Goose & MLA Project Sites – 2024 Annual Geotechnical Inspection

Back River Project, Nunavut, Canada
B2Gold Corp.

SRK Consulting (Canada) Inc. ■ CAPR003105 ■ April 2025

Job No: CAPR003105 Filename: BackRiver_MLA&Goose_2024AGI_Figures..pdf	 Back River Project	2024 Annual Geotechnical Inspection		
		Goose Airstrip – Ponding Water		
		Date: 2025-03-11	Approved: JBK	Figure: 4

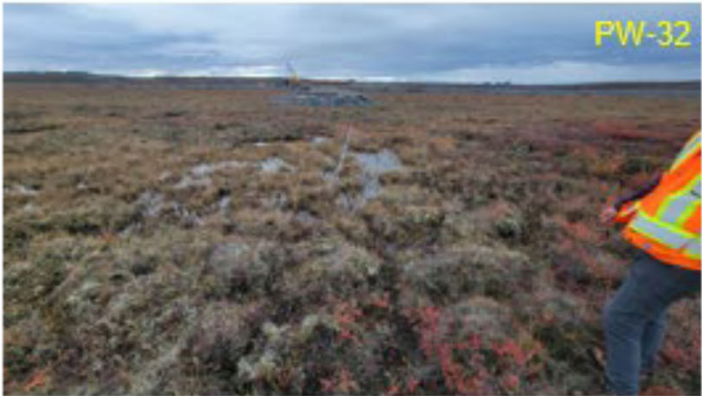
Ponding water and bodies of water near pads.

Date: 2024-09-12	Approved: JBK	Figure: 29
---------------------	------------------	---------------

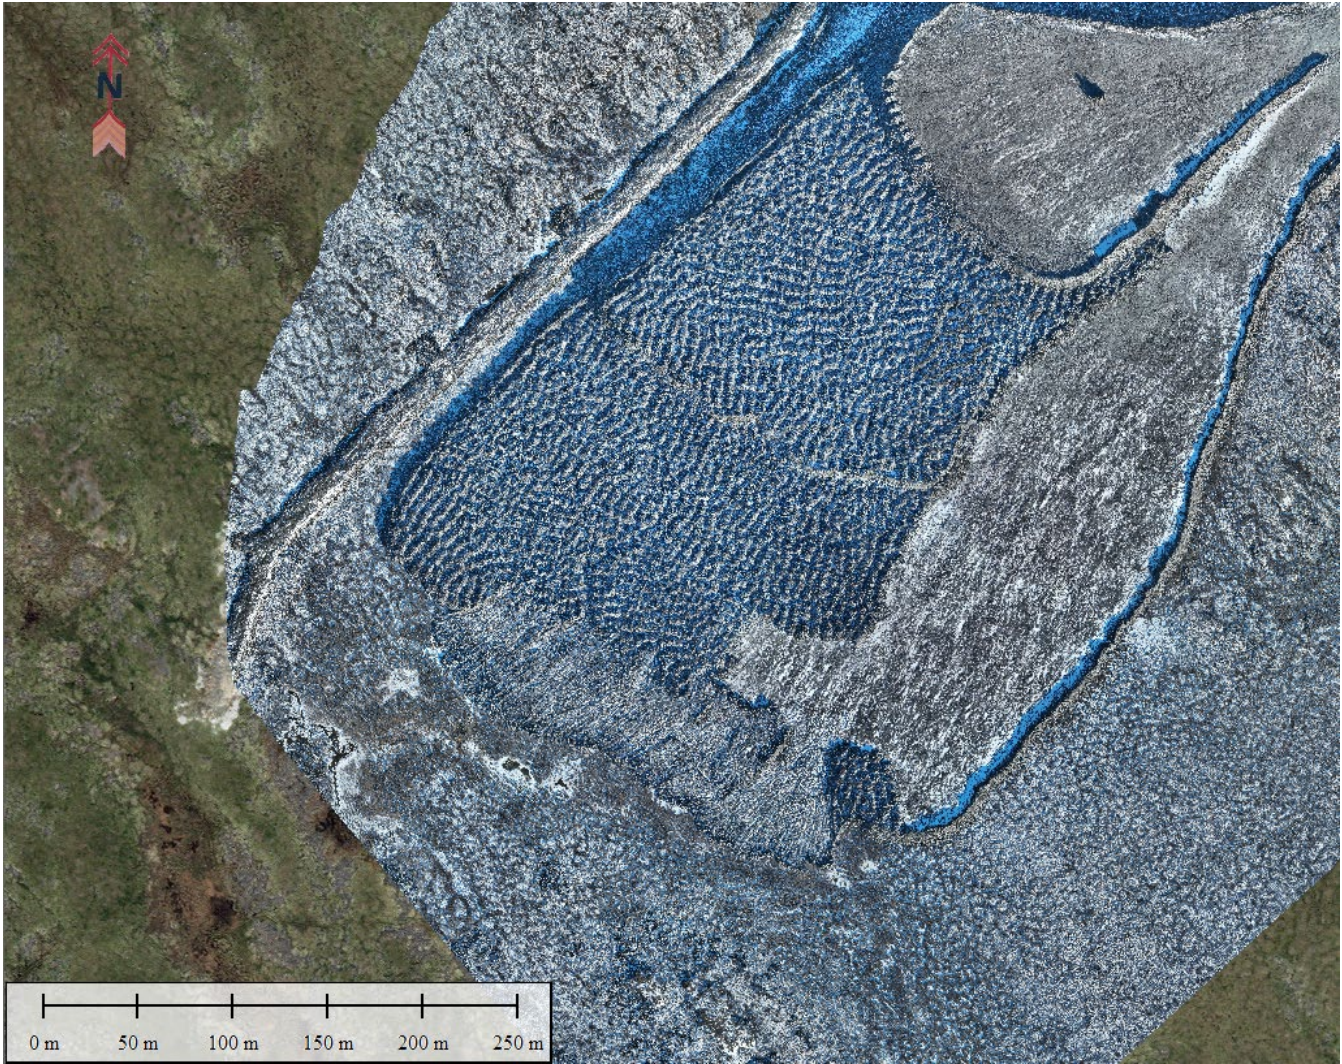
G-68: Southern Side of Echo Pit Haul Road – Note two Culverts are elevated approx. 0.5m from toe of embankment. Culverts partially blocked

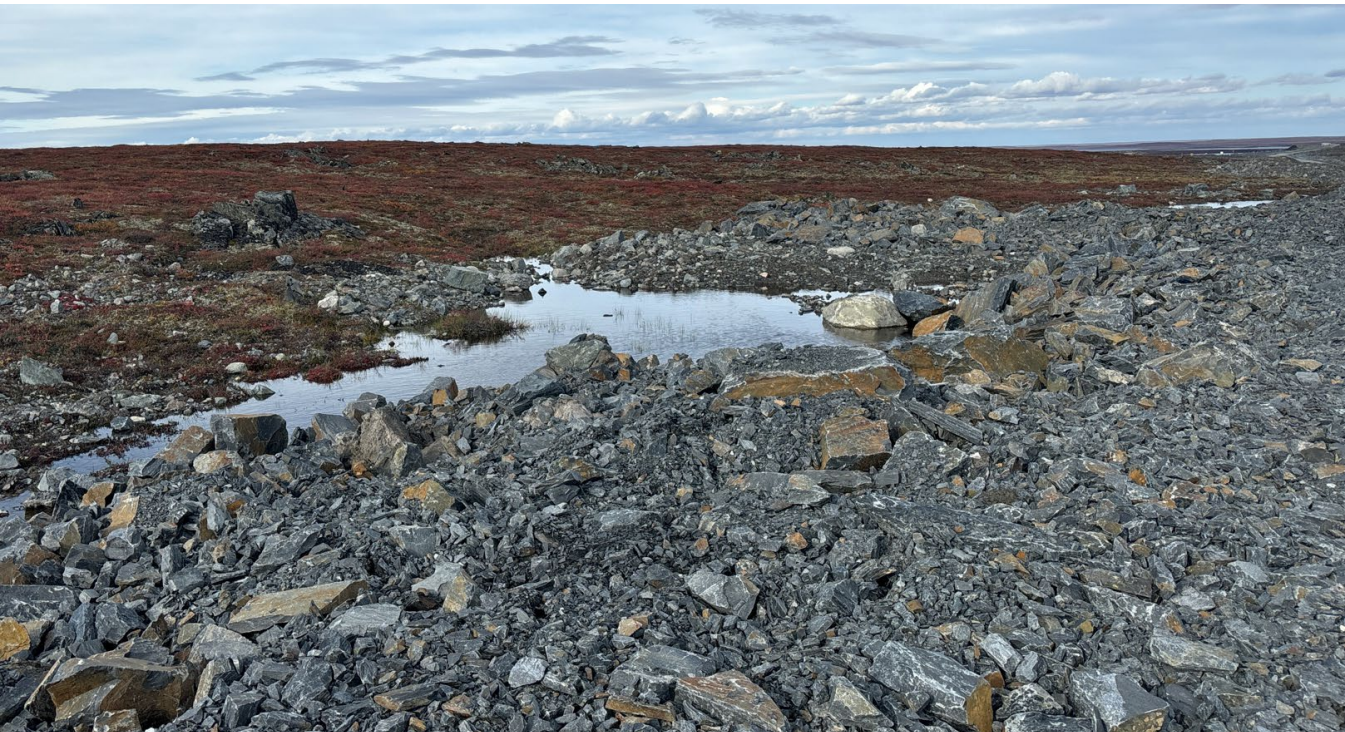
G-72: Diversion, facing west – Note thickness less than 1m

2024 Annual Geotechnical Inspection		
		Echo Treatment Pond		
Job No: CAPR003105 Filename: BackRiver_MLA&Goose_2024AGI_PhotoLog.pdf	Back River Project	Date: 2024-09-12	Approved: JBK	Figure: 42

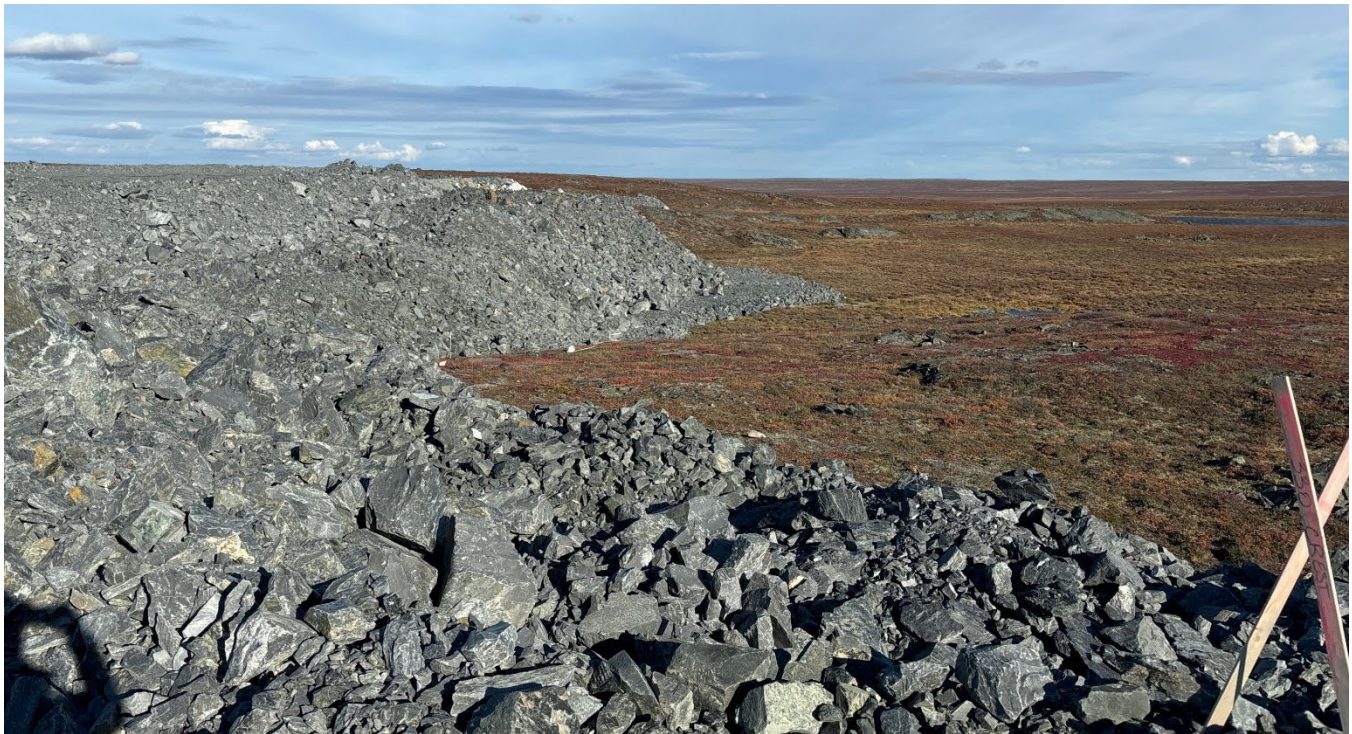
G-99: Southern end of WRSA, facing SE – Note oversteepened slopes

G-100: Southern end of WRSA, facing east – Note waste rock dumping in lake pond

Job No: CAPR003105 Filename: BackRiver_MLA&Goose_2024AGI_PhotoLog.pdf	 Back River Project	2024 Annual Geotechnical Inspection		
		Camp Pad		
		Date: 2024-09-12	Approved: JBK	Figure: 79

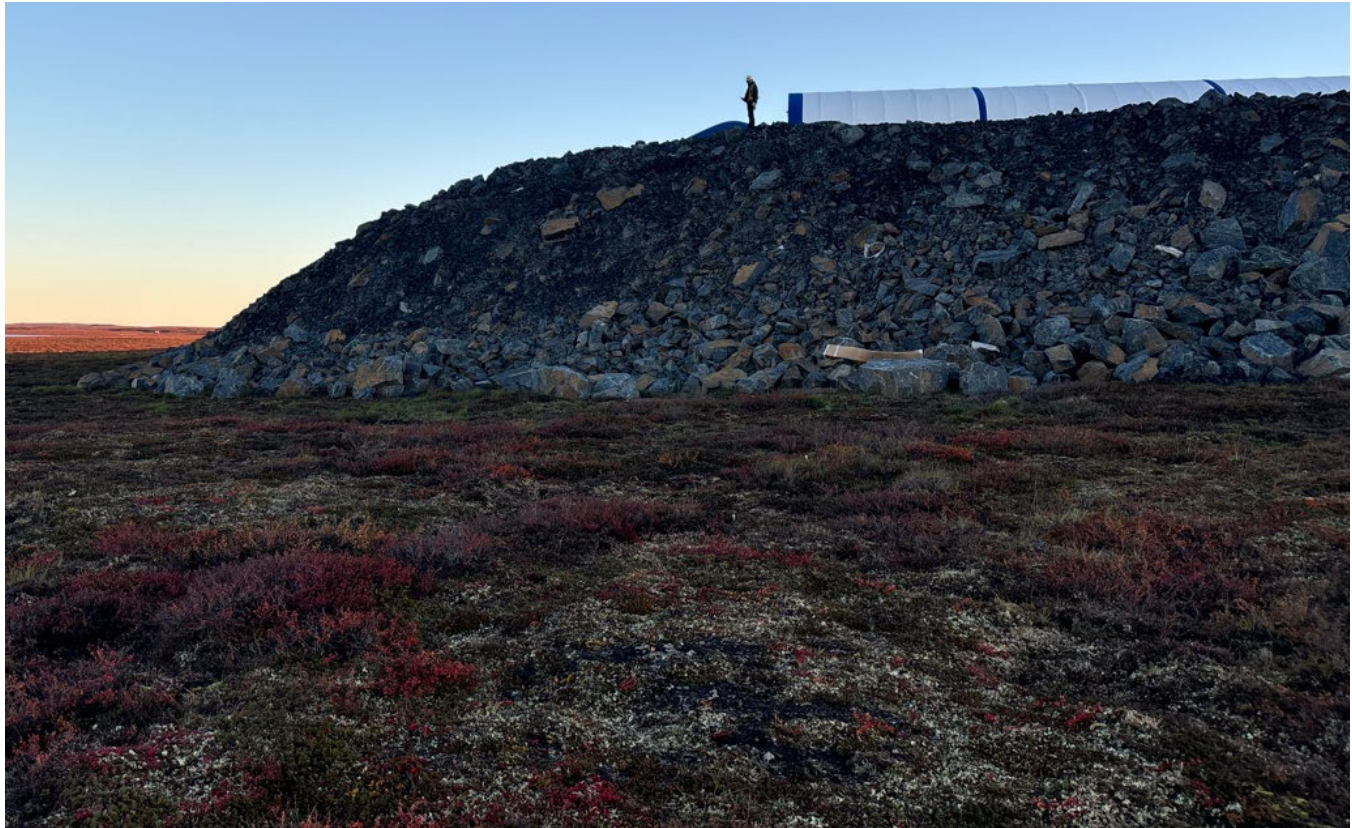
G-180: South facing slope – Note oversteepened, rockfall evident

G-181: Discharge area – Note Oversteepened slope, equipment can be damaged by falling rocks

2024 Annual Geotechnical Inspection		
		MLA Quarry Tank Farm		
Job No: CAPR003105 Filename: BackRiver_MLA&Goose_2024AGI_PhotoLog.pdf	Back River Project	Date: 2024-10-23	Approved: JBK	Figure: 11

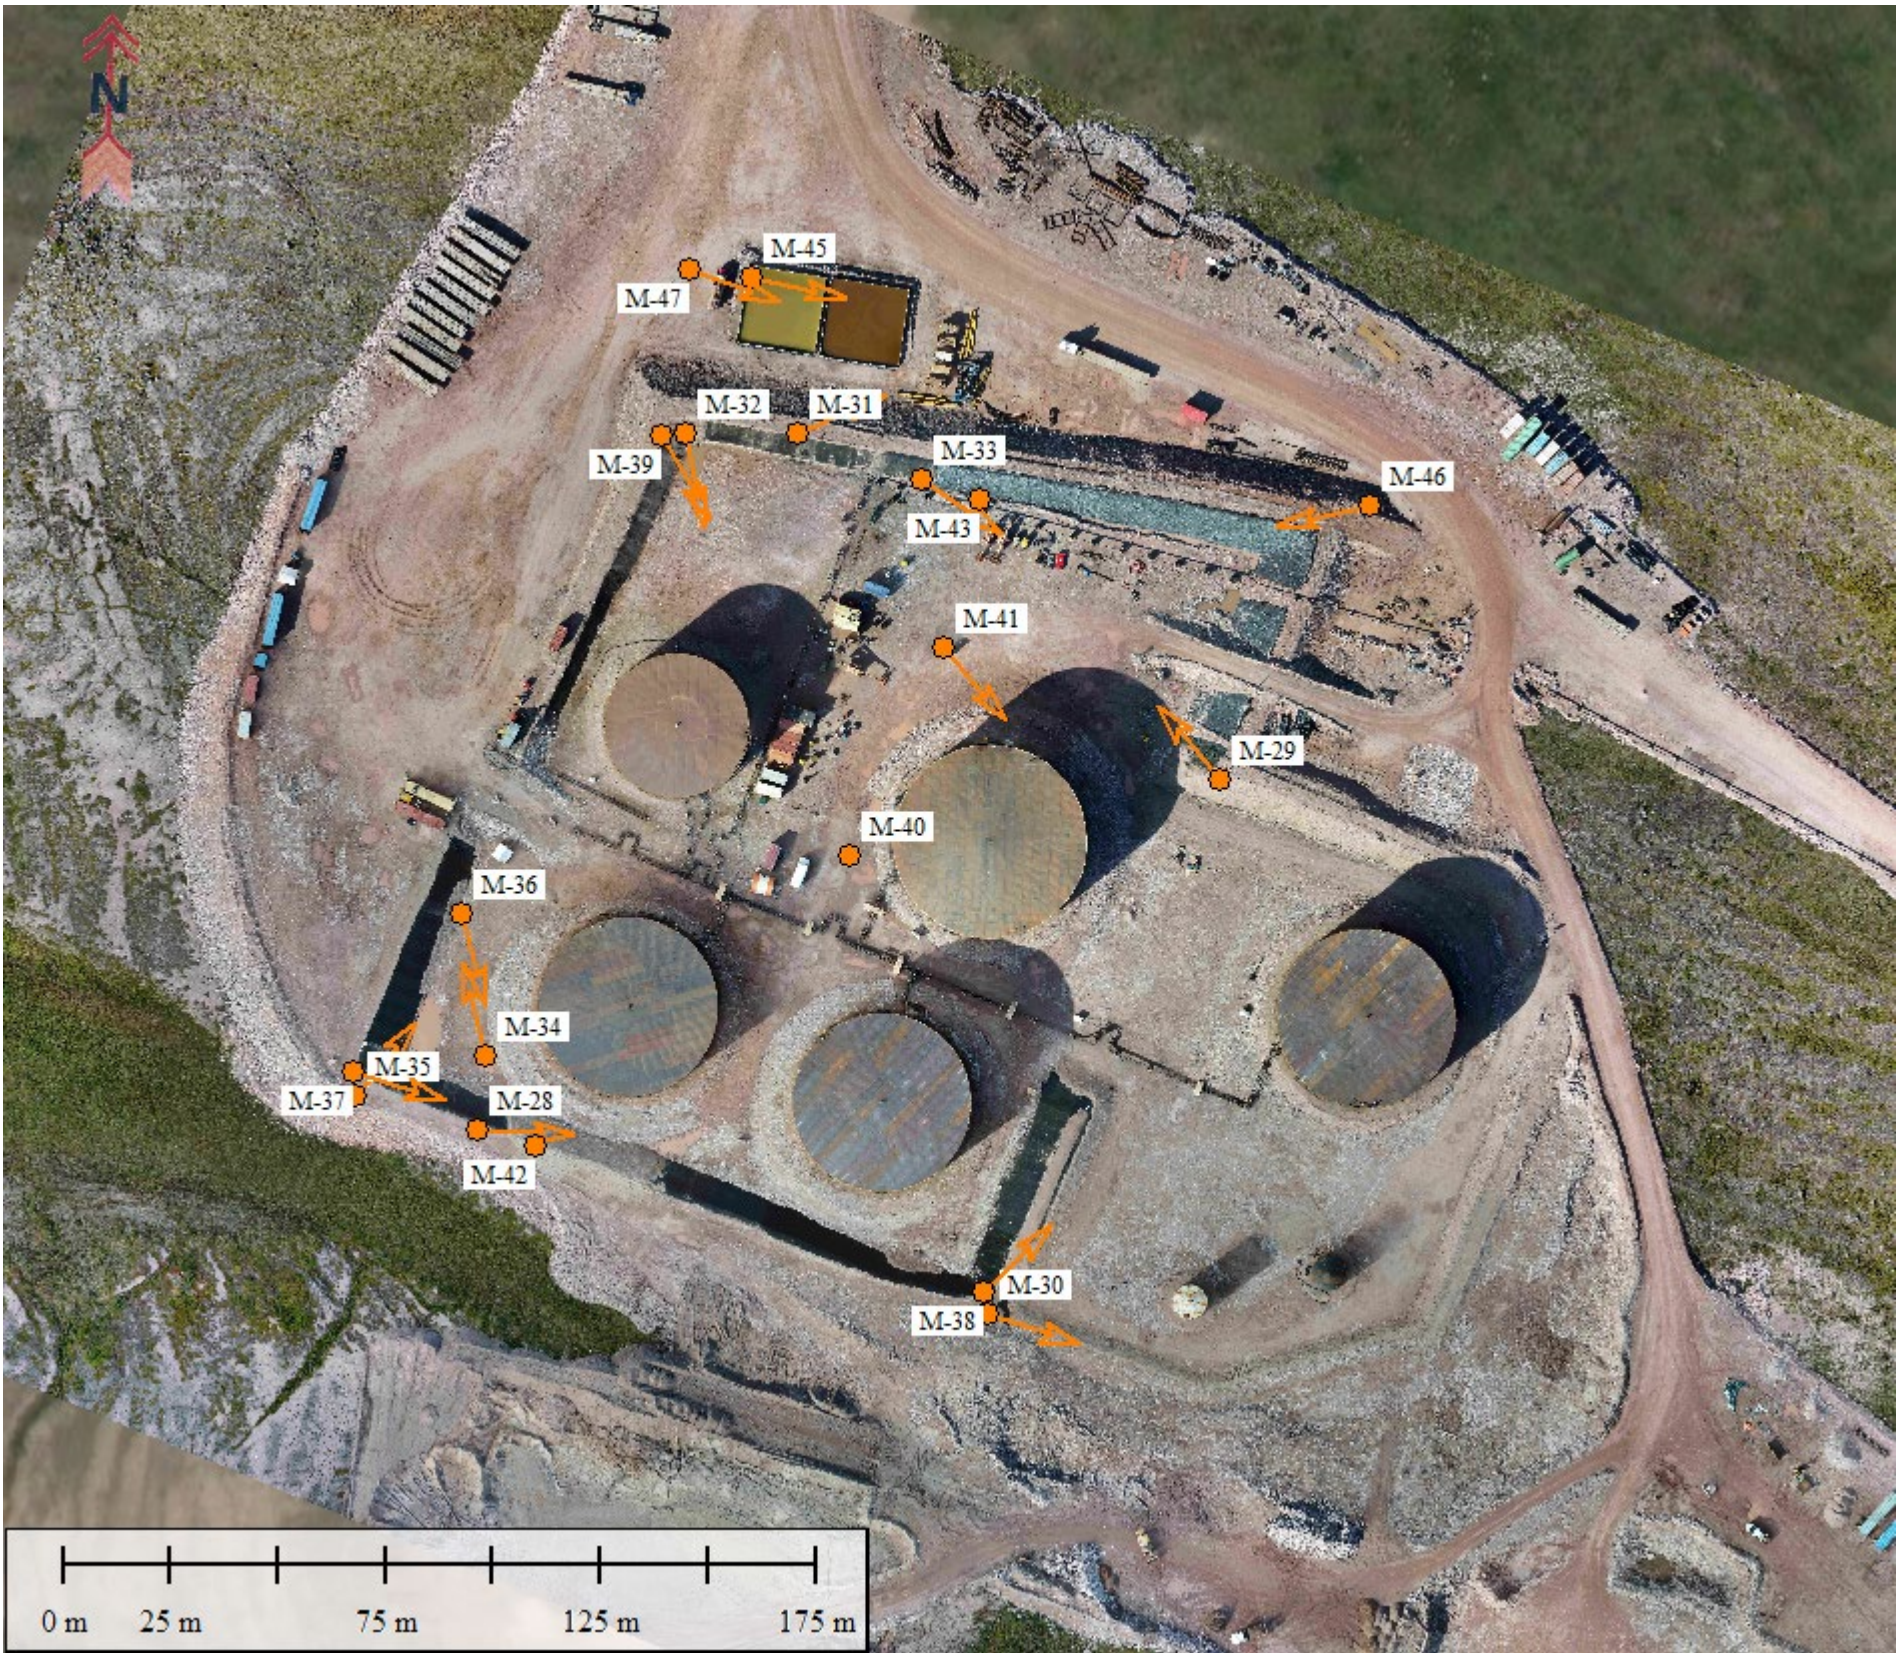
M-28: Liner fill is too thin, to allow equipment on the berm min 0.6 m of fill is required

M-29: Ponding water due to the ramp access
